Docket No. 50-409

IE Bulletin No. 80-20

FAILURES OF WESTINGHOUSE TYPE W-2 SPRING RETURN TO NEUTRAL CONTROL SWITCHES

FIGURE 1:

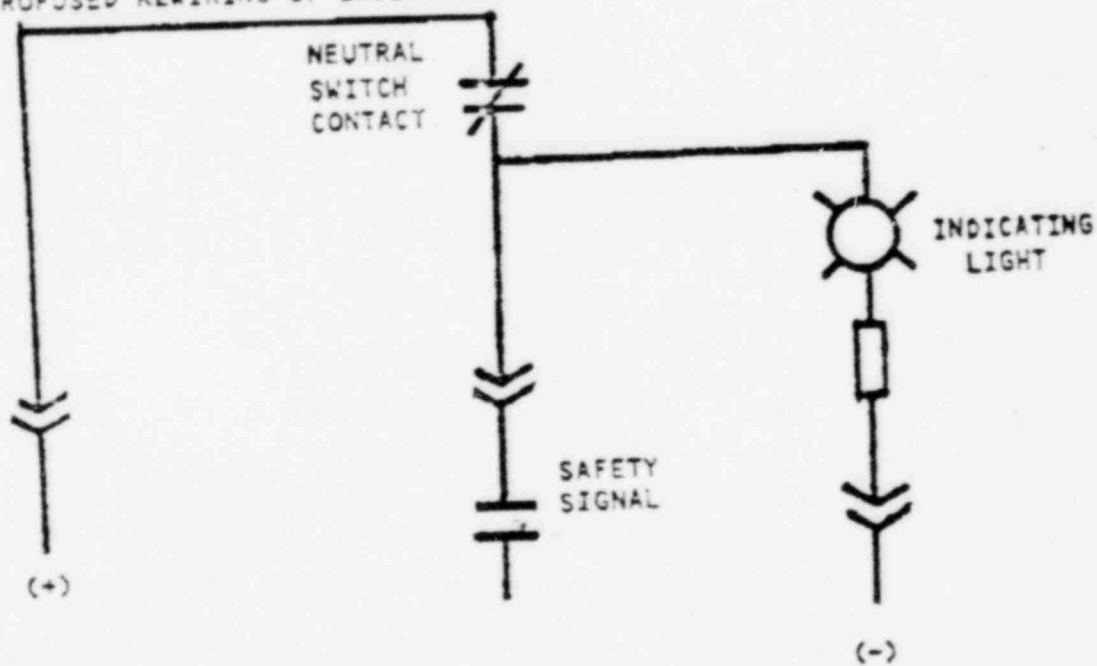
A review of this matter by Westinghouse led to the issuance of NSD Technical Bulletin No. NSD-TB-80-9 to the utility owners of all Westinghouse operating plants. The recommendations contained in the Westinghouse technical bulletin include: (i) testing the neutral position contacts of the subject W-2 switches for continuity, and (ii) rewiring of the indicating light circuit to permit the early detection of a neutral contact failure as shown in Figure 1.

Depending on how the indicating light circuit is wired, loss of continuity thru the neutral position contact of a W-2 switch could remain undetected until the equipment associated with the switch were called upon to operate. Since such a failure would be equivalent to by-passing the system associated with the switch, consideration should be given to rewiring the switches used in safety-related applications as shown in Figure 1. Such rewiring would provide an acceptable means for detecting contact failure, provided the indicating light is in the control room and readily visible by the operator. If the indicating light is not so located, consideration should be given to annunciating the neutral position contact failures at the control room to alert the operator of the inoperable status of a safety-related system. In addition, consideration should be given to adding redundant contacts to the W-2 switches or to replacing the W-2 switches with others having a more positive contact wiping action.

3. Licensees of operating plants and holders of construction permits shall describe the longer term corrective measures planned and the date by which such measures will be implemented by actual installation or by design change, as appropriate. As a minimum, the longer term corrective measures should include rewiring the indicating light as shown in Figure 1 provided the light is readily visible to the control room operator. If not, failures of the neutral position contacts should be annunciated in the control room.

REWIRING OF INDICATING LIGHT CIRCUIT OF W-2 SWITCHES
AS RECOMMENDED BY WESTINGHOUSE TECHNICAL BULLETIN NSD-TB-80-9
